## **DESCRIPTION AND ASSESSMENT OF THE PROPOSED CHANGE**

Ameren Missouri (Union Electric Company) is proposing to amend Operating License NPF-30 for Callaway Plant ("Callaway"). The proposed amendment would add a note to Technical Specification (TS) 4.2.2, "Control Rod Assemblies," to permit the Cycle 28 core to contain 52 control rods (i.e., with no control rod in core location H-08) in lieu of the current requirement for 53 control rods. A Callaway operating cycle is nominally 18 months.

The proposed amendment would revise TS 4.2.2 to add a note permitting operation with 52 control rods during Cycle 28, in lieu of the requirement for 53 control rods. Ameren has reviewed the Callaway TSs and has determined that no additional TS changes are required.

**Figure 1 – Control Rod Locations**

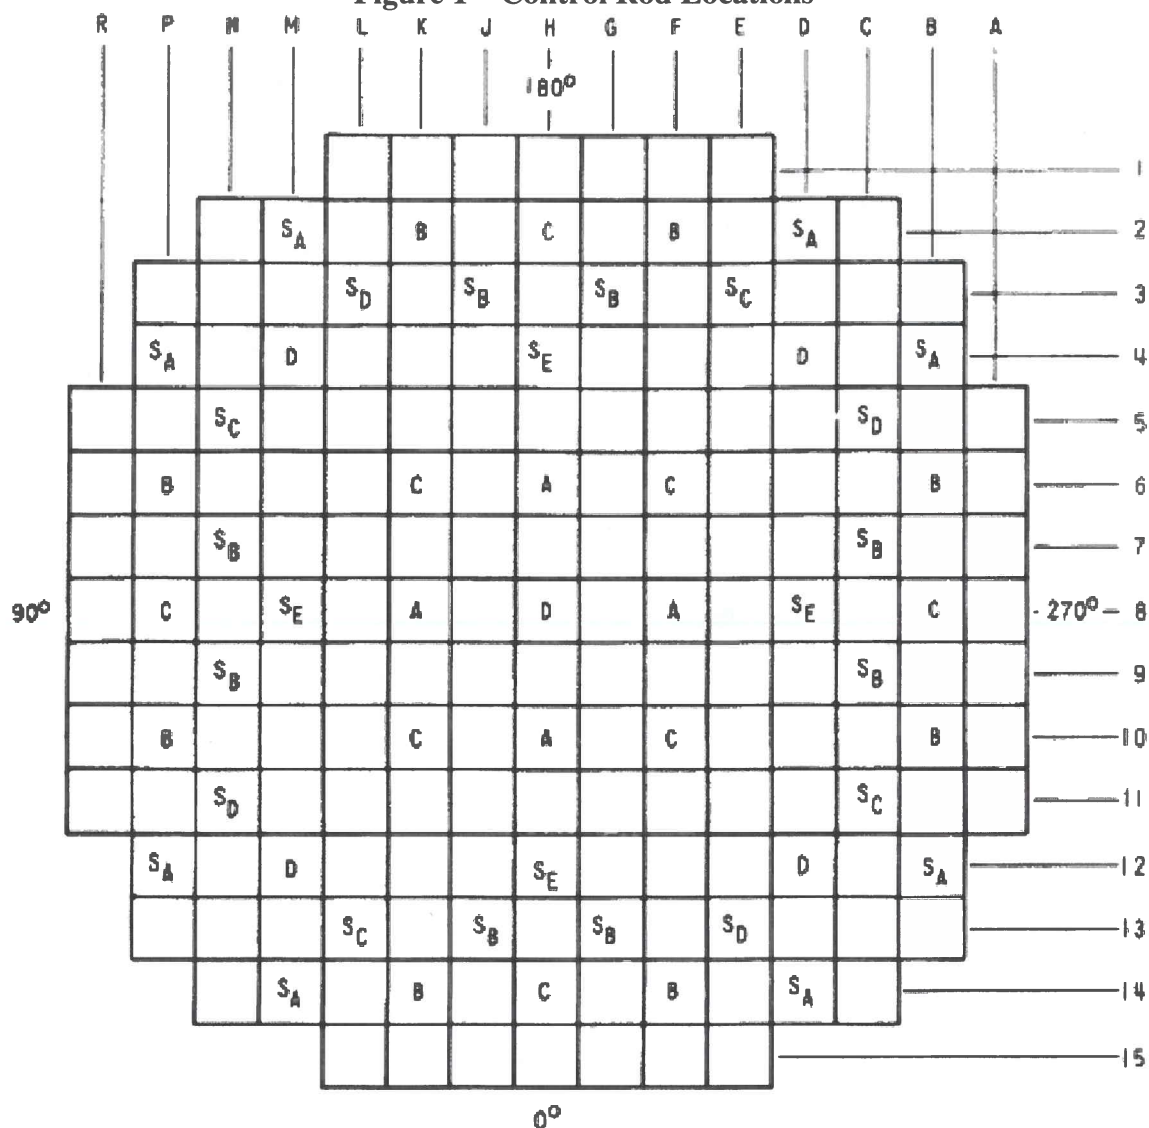
The H-08 control rod is part of Control Bank D and is located in the center of the core as shown in Figure 1. With the removal of the H-08 control rod, the core during Cycle 28 will contain 52 control rod assemblies. Table 1 shows the number of rods in each bank.
